# Access Compliance Report

## Public Rights-of-Way

### (Curb Ramps)

Intersection ID: N/A	Main Street: WALNUT_LOOP_RD	Cross Street: MARSHALL_BRIDGE_RD	Location: SE
ADA ID: F3EEEE5515D3	Ramp Type: Perp	Initial Pass/Fail: Fail	Overall Compliance: No
Severity Score: 12.5			
Codes/Mitigation Info/Possible Solution		Field Measurements/Component Compliance

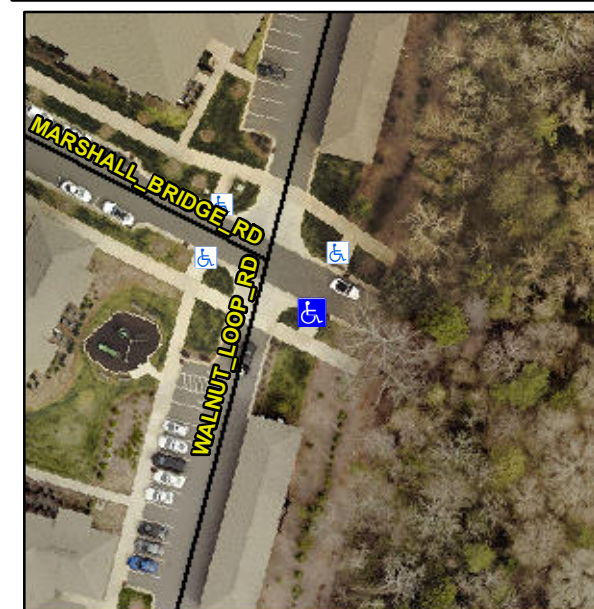
**Not Found, R304.2.2**

Compliance	Description	Data	Compliance	Description	Data
N/A	Ramp Length (in)	155.0	No	Ramp Slope (%)	9.0
Yes	Ramp Width (in)	93.0	Yes	Ramp XSlope (%)	1.6
N/A	Flare Type LT	N/A	N/A	Flare Type RT	N/A
N/A	Flare Slope LT (%)	N/A	N/A	Flare Slope RT (%)	N/A
N/A	Flare Traversable LT?	N/A	N/A	Flare Traversable RT?	N/A
N/A	Landing Length (in)	N/A	N/A	DWS Provided?	N/A
N/A	Landing Width (in)	N/A	N/A	DWS Contrast?	N/A
N/A	Landing Slope (%)	N/A	N/A	DWS Length (in)	N/A
N/A	Landing X Slope (%)	N/A	N/A	DWS Full Width?	N/A
N/A	Landing Curb? (Y/N)	N/A	N/A	DWS Offset (in)	N/A
N/A	Shared Landing?	N/A			
N/A	Gutter Ponding?	N/A	N/A	Gutter Slope (%)	N/A
N/A	Gutter Lip Ht (in)	N/A	N/A	Gutter X Slope (%)	N/A
N/A	Painted X Walk1?	No	N/A	Painted X Walk2?	N/A
	X Walk 1 Direction	To NE		X Walk 2 Direction	N/A
N/A	X Walk 1 Width (in)	N/A	N/A	X Walk 2 Width (in)	N/A
	X Walk 1 Slope (%)	3.9		X Walk 2 Slope (%)	N/A
	X Walk 1 X Slope (%)	0.5		X Walk 2 X Slope (%)	N/A

**Remove & Replace Entire Ramp.**
